GENERAL MOTORS NORTH AMERICA
Structures & Safety Integration

NVS-2120ag
EA03-007 supplement

This letter is General Motors' (GM) response to your information request (IR), dated October 27, 2003, regarding allegations of engine stall in 2002 Model Year (MY) GMT 360 vehicles - GMC Envoy and Oldsmobile Bravada vehicles equipped with Electronically Controlled Air Springs (ECAS).

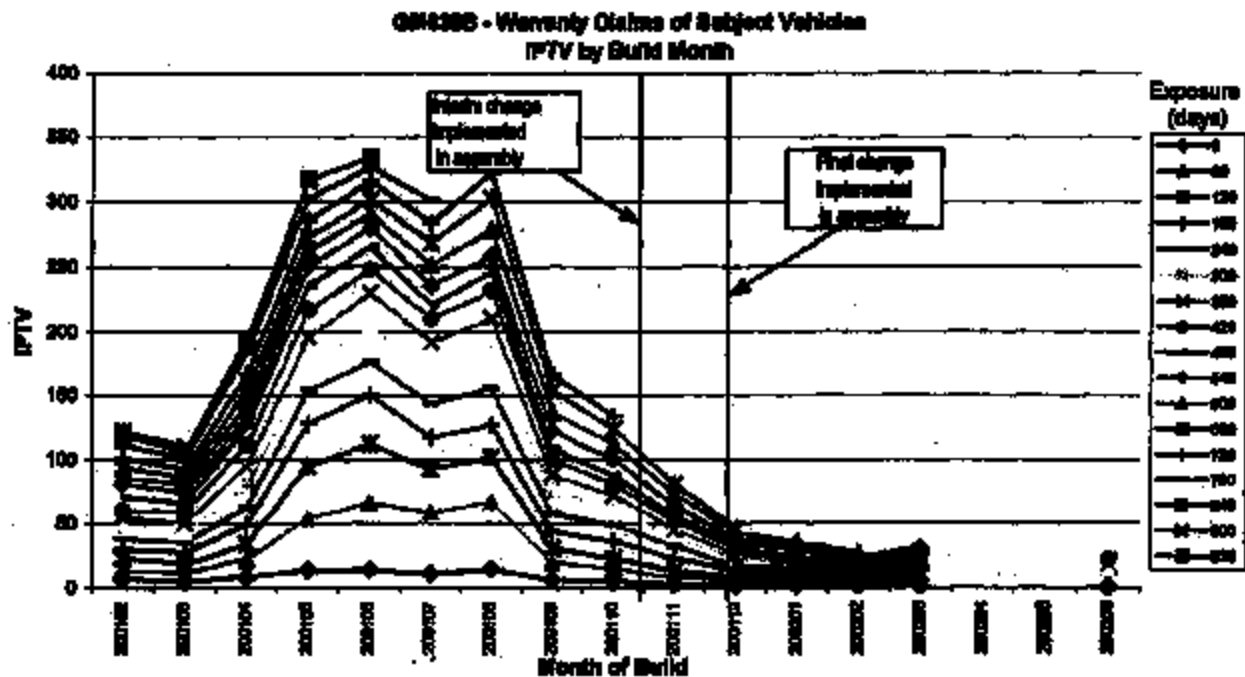
5. In response to Request No. 14 of the EAIR, GM calculated the Incident Rate Per Thousand Vehicles (IPTV). Please define the calculation formula, identify the range of data used to perform the calculation, provide the supporting data, and explain GM's assessment of the IPTV.

GM calculated the warranty IPTV of the out-of-scope vehicles by dividing the warranty claims (provided in response to Q14 of the EAIR) for each out-of-scope vehicle model by the corresponding out-of-scope vehicle population (provided in response to Q9 of the EAIR, see below) and then multiplying by 1000.
